SERVICE BULLETIN

BULLETIN NO: 18-007

TITLE: Drive Axle Mounting Bracket Welding

PRODUCT SERIES / MODEL: 6700, MARK IV and Drone Tampers

FIGURE 1
UNWELDED ASSEMBLIES

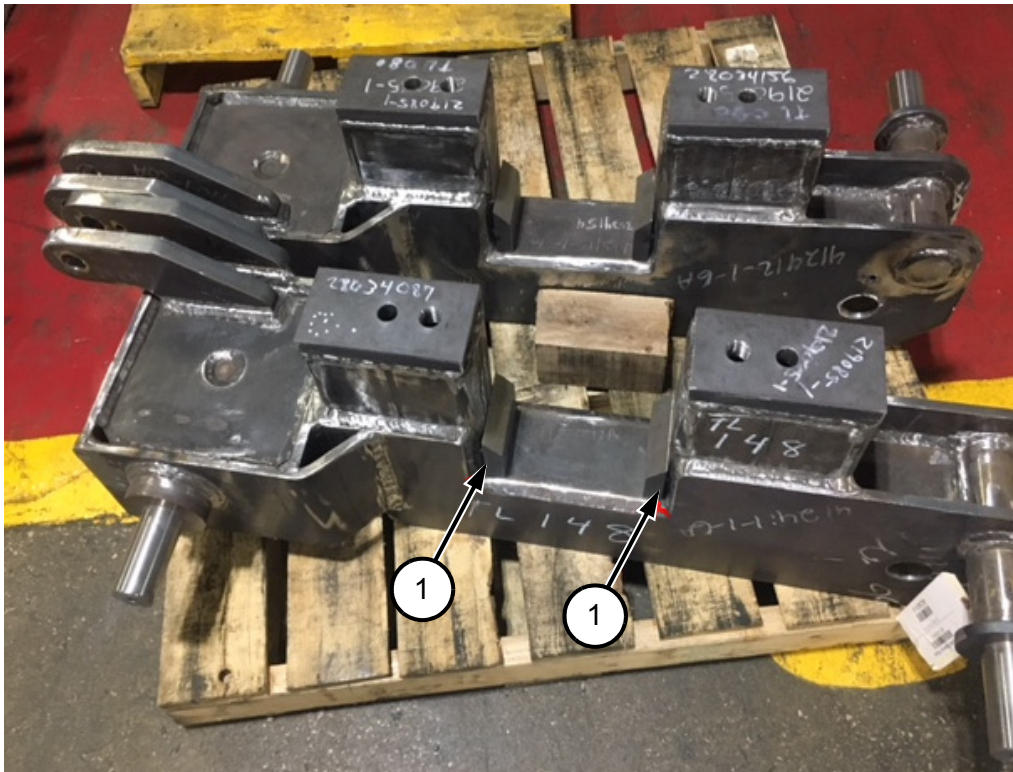
1. Customers need to review purchase history and inventory of the assemblies to determine if tabs (1) are fully welded or just tack welded. If the assembly is on a machine, the tabs must be fully welded. If the assemblies are in you inventory, the tabs must be fully welded when they are installed on the machine. Harsco will provide a list of each sales order and delivery date for each unit sold as well as detailed shipping information upon request.

FIGURE 2
WELD DETAIL

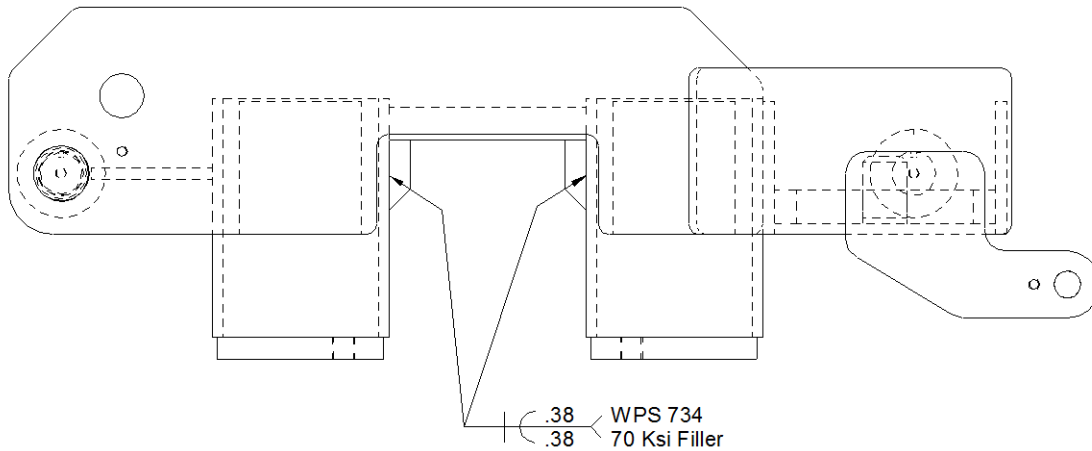
- 2. Weld tabs (1) on the drive axle mounting brackets installed on the machine per details shown in Figure 2 and 3.

- 1. For the rebuild process the customer should either have a fixture made or have these welded in place once the rear drive is installed to ensure correct alignment.
- 2. Axles can be used as a fixture.
